Re: Supplemental Submission No. 4 for Rezoning Application Case No. 20983

Stonehaven at Rockingham South (PIDs 00293308, 40433849 and 40433858), off Wentworth Drive & Dunbrack Street, Rockingham South, HRM.

To the Halifax Development and Planning offices,

Please consider the modifications to the Wentworth Drive development proposal for rezoning. The changes are based on various comments from Karen Godwin and Jamy-ellen, as well as an ongoing discussion between KWR (Kevin Riles) and the respective departments.

SITE - GROSS LOT AREA

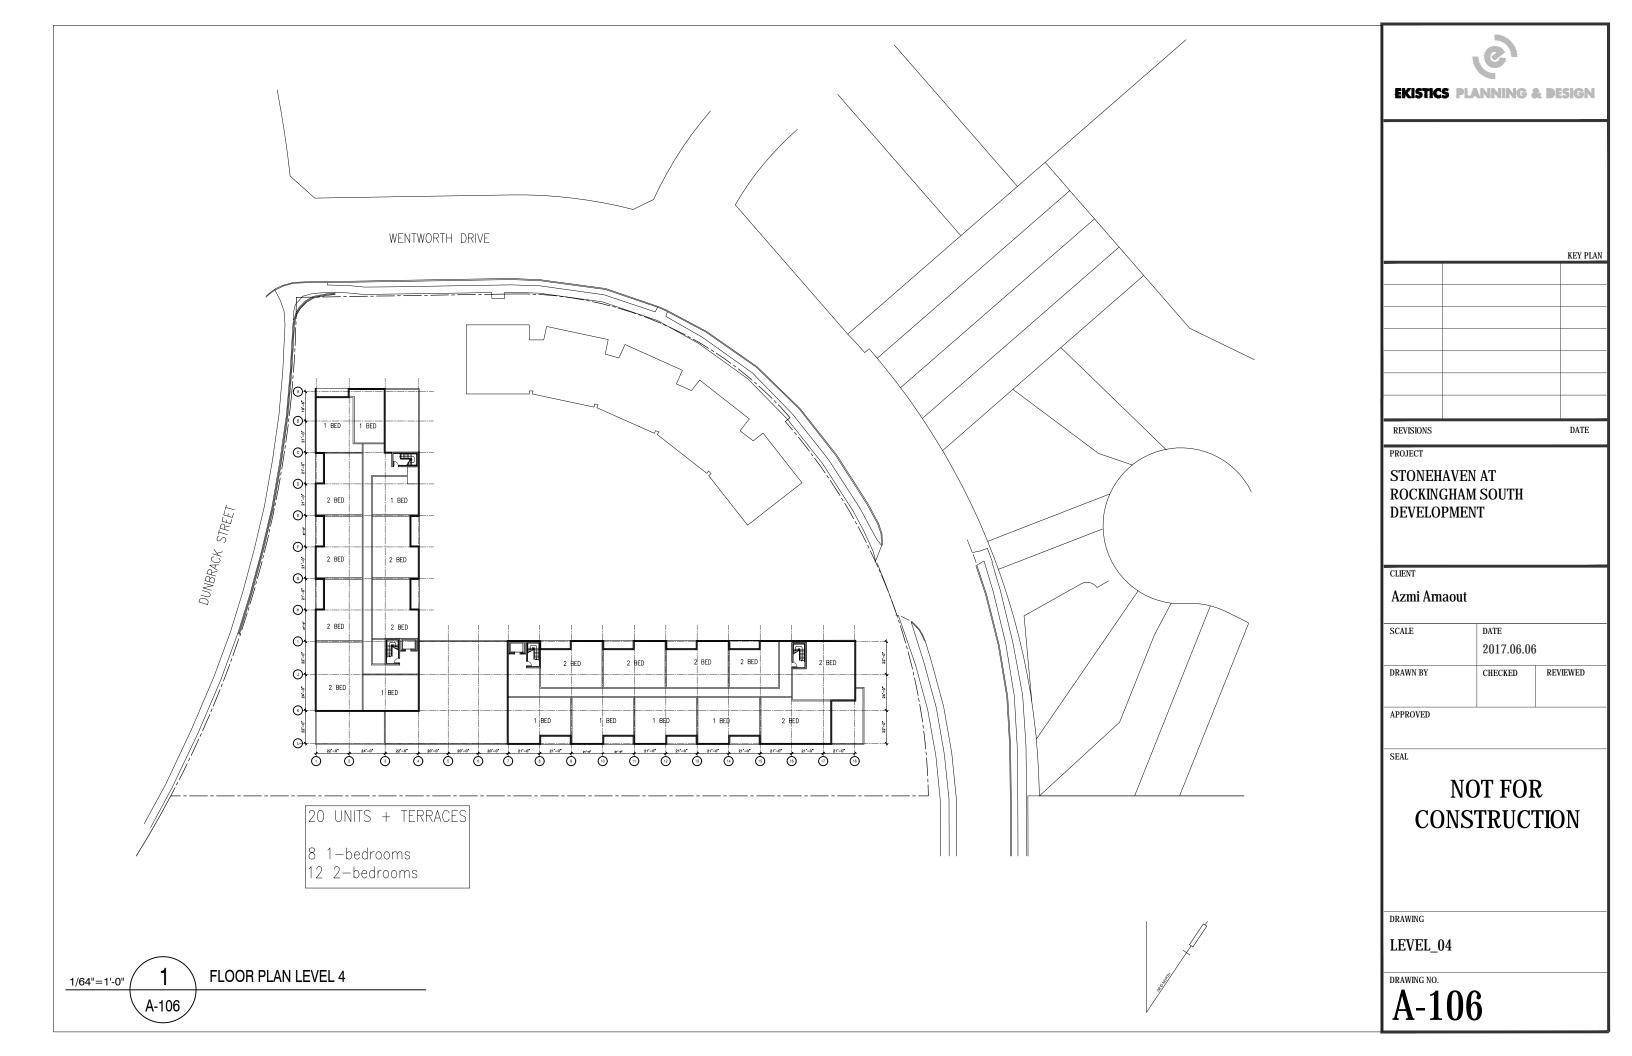
02 Density Calculation: See attached Gross Lot Area drawing A-100 illustrating the 30' extension into the facing streets – in both cases lesser than the center of street. The *Gross Lot Area* is 3.69 acres, for a total density of 277 persons (75 persons / acre). The combined density of the Multi-unit building and the Townhouse is 276 persons for the entire site.

A-110

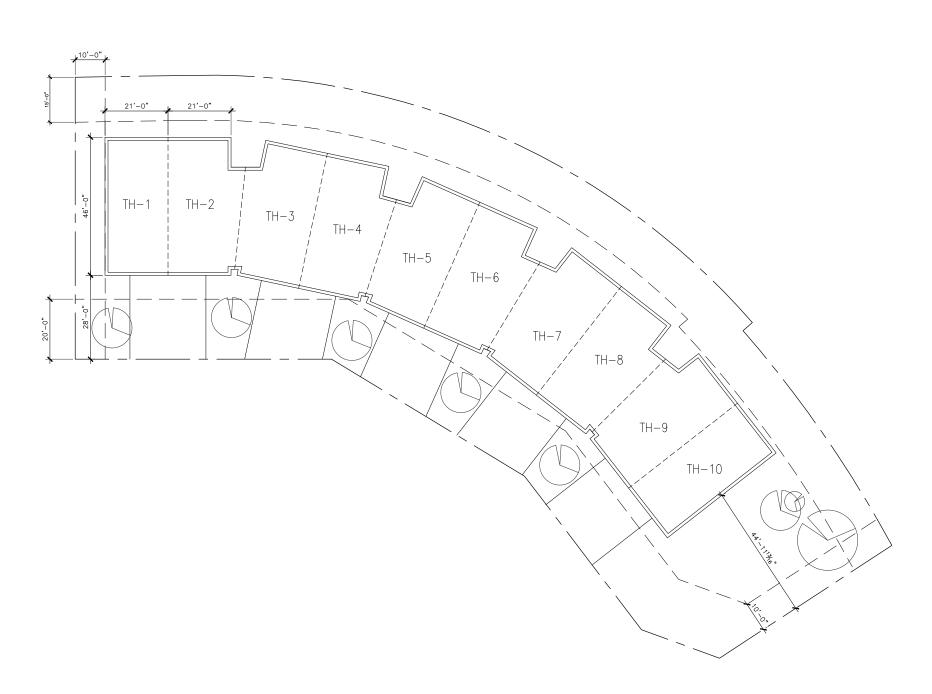
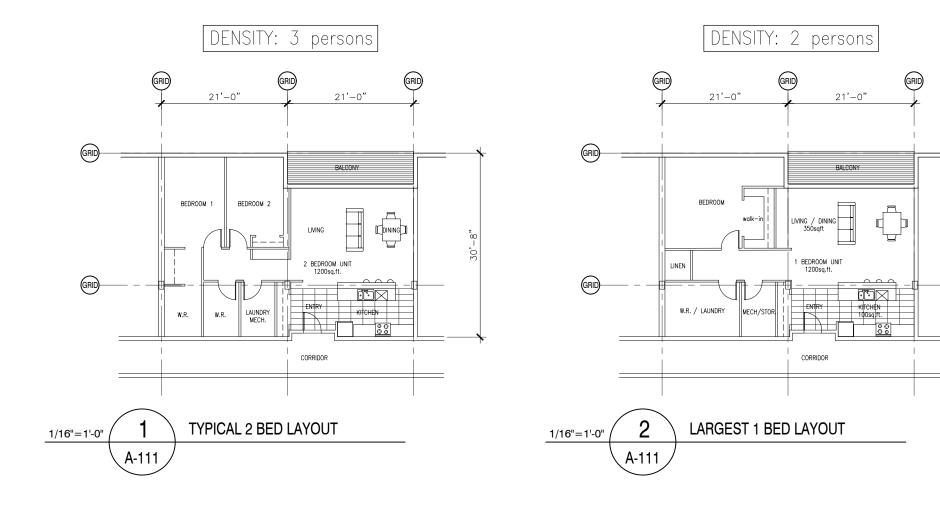
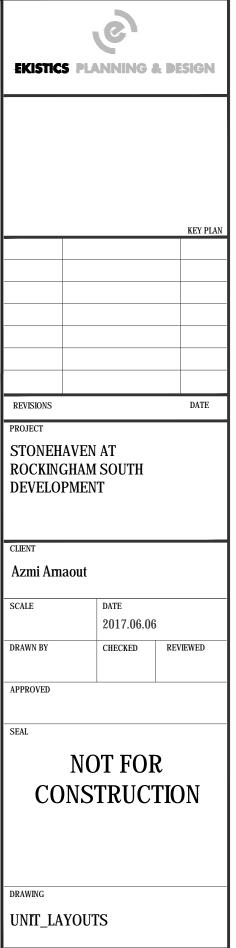
01 Townhouse Design: The townhomes have been merged into one townhouse building with 10 units. They share a significant common wall (full height) and meet the requirements for the R-2T zone. All the setbacks and zoning requirements are compliant. This also provides more space between the Multi-Unit Building and along the Wentworth Side entry for more landscape features. See drawing A-110 for townhouse site plan and setbacks.

A-111

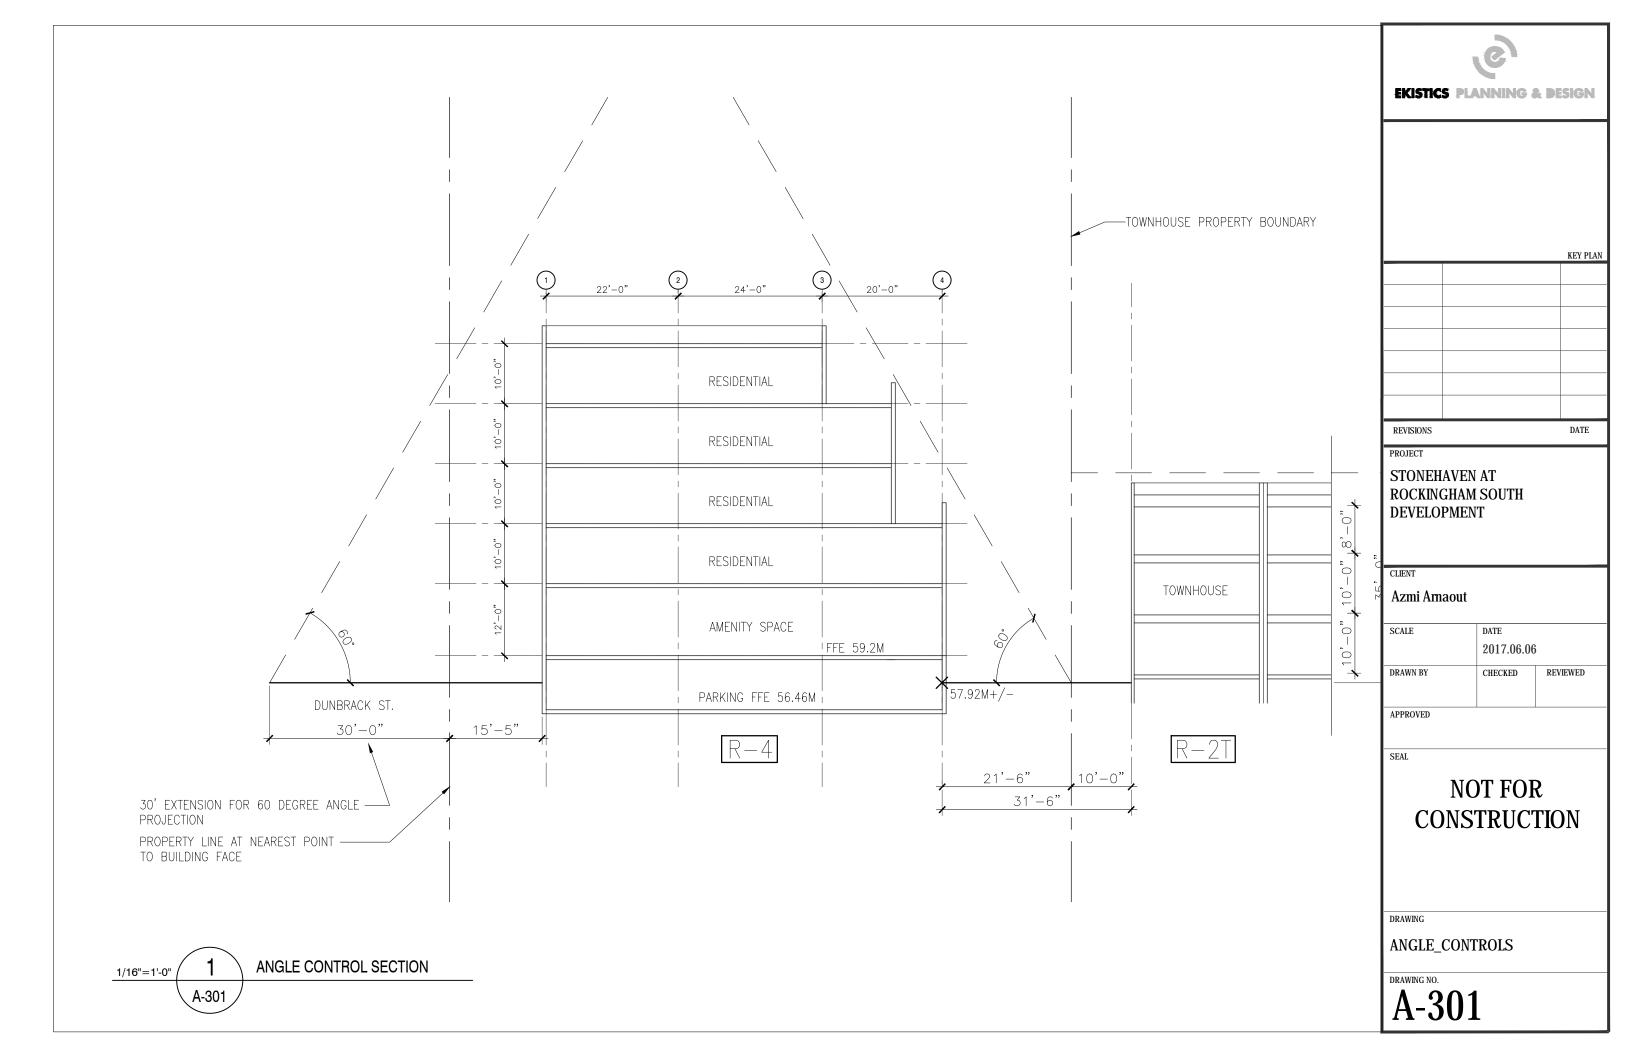
03 Multi-Unit Building: Based on the density calculation of 277 people, we have reconfigured the unit mix and type within the multi-unit building, resulting in 93 units (43 1-bedrooms and 50 2-bedrooms). Recognizing that the density per unit is based on the *Habitable Rooms* definition, we have included a layout for the largest 1-bedroom unit to illustrate that it does not exceed the 2-person density used in our calculations. See drawing A-111 for largest 1-bedroom layout.
